**DRAFT SYDNEY DEVELOPMENT
CONTROL PLAN 2012 –
GAZCORP SITE AMENDMENT
DATED MAY 2017**

**POST EXHIBITION CHANGES
MARKED IN RED**

Gazcorp Site Amendment
May 2017

6.3.X 296-298 Botany Road and 284 Wyndham Street, Alexandria

Figure 6.XX: Section 3

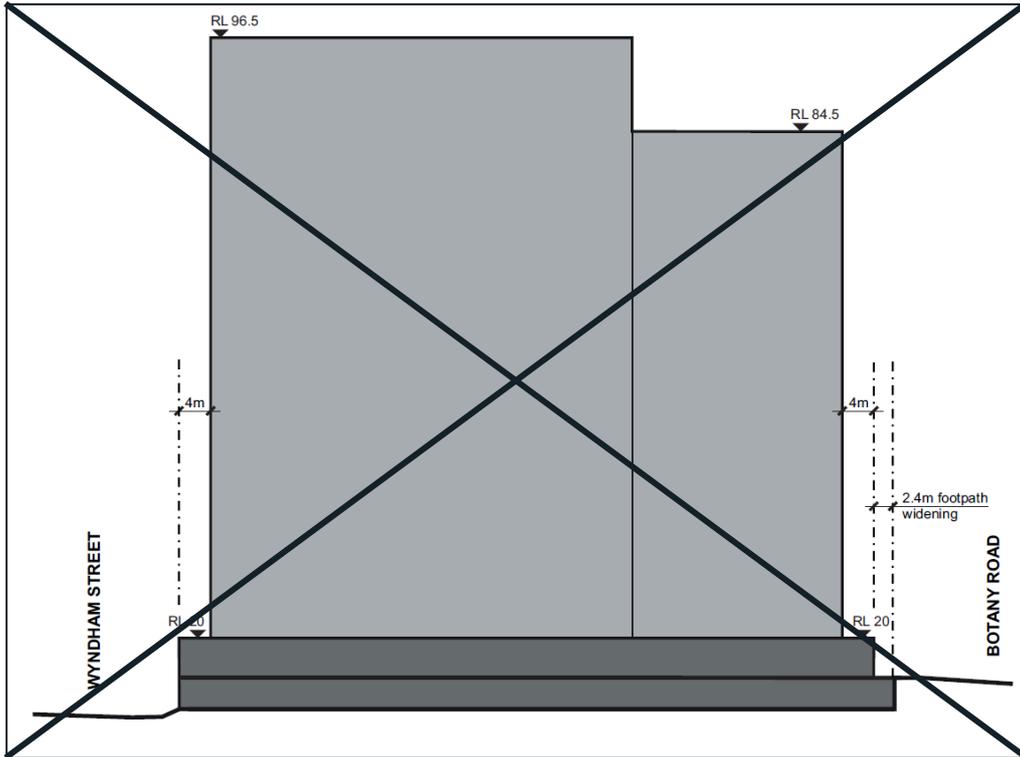
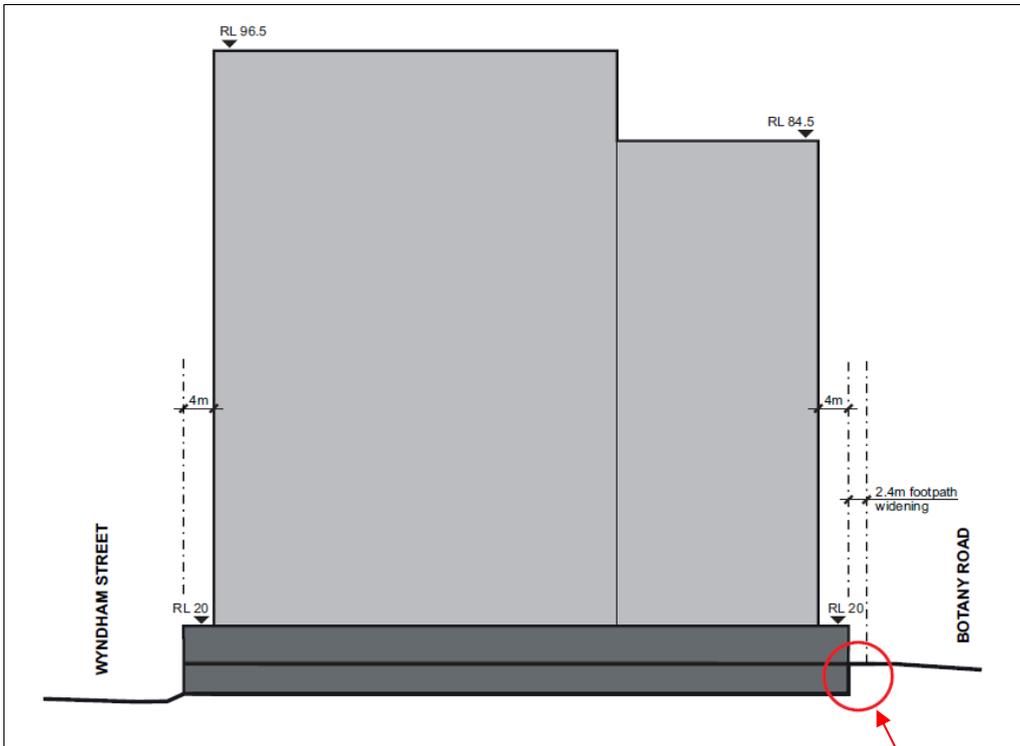
Correction to align basement with footpath setback.

Figure 6.XX: Section 4

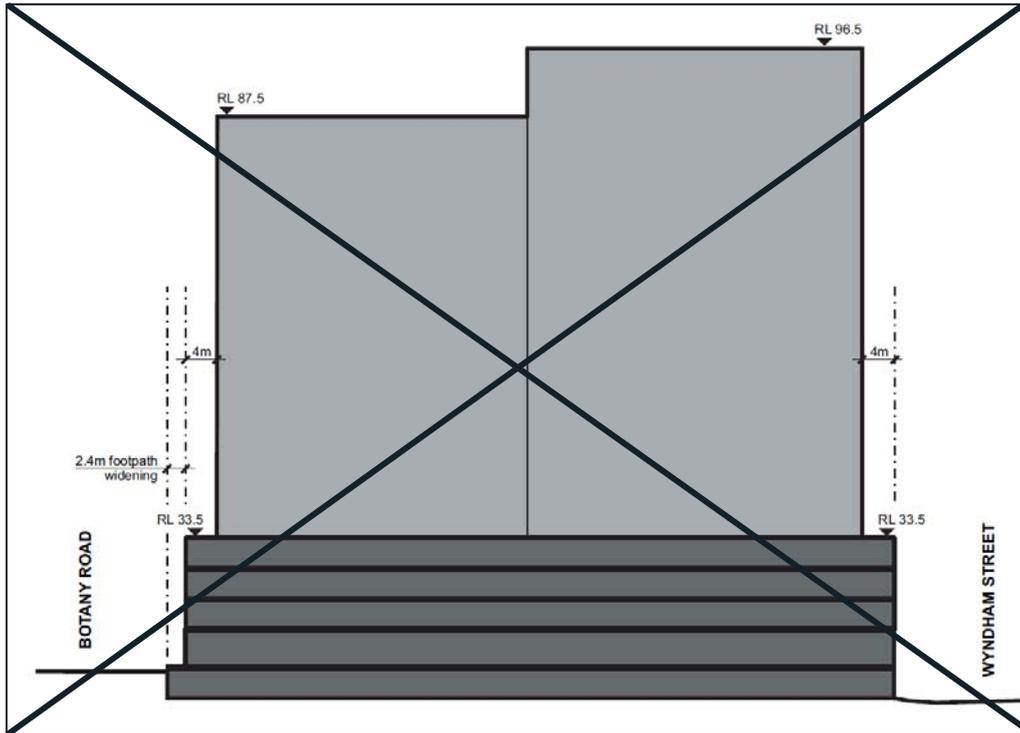
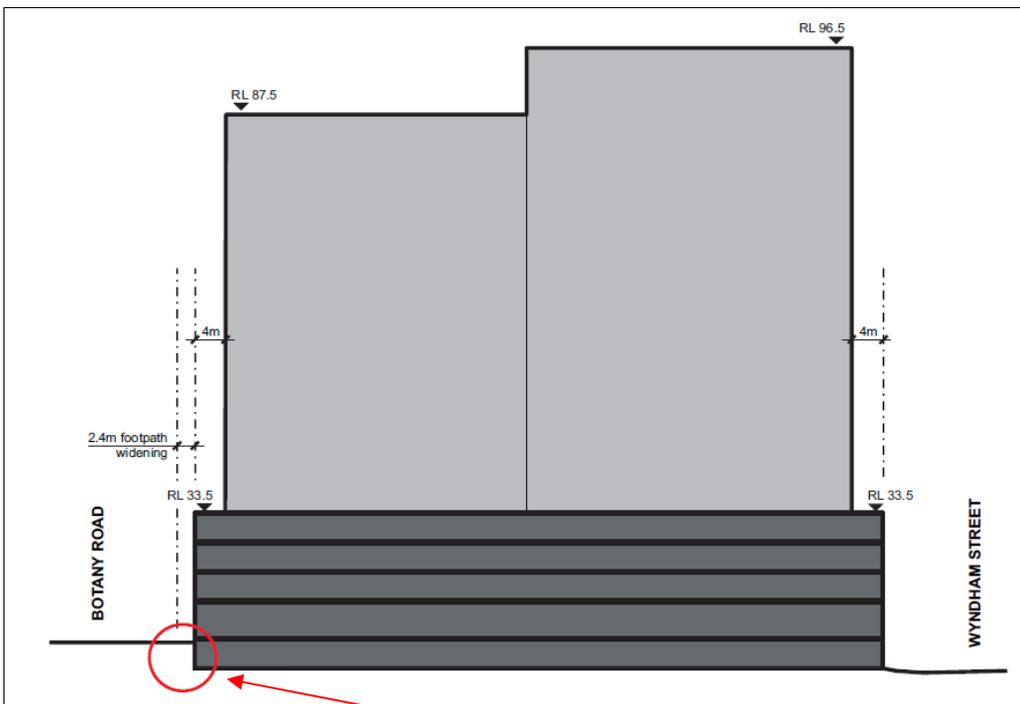
Correction to align basement with footpath setback.
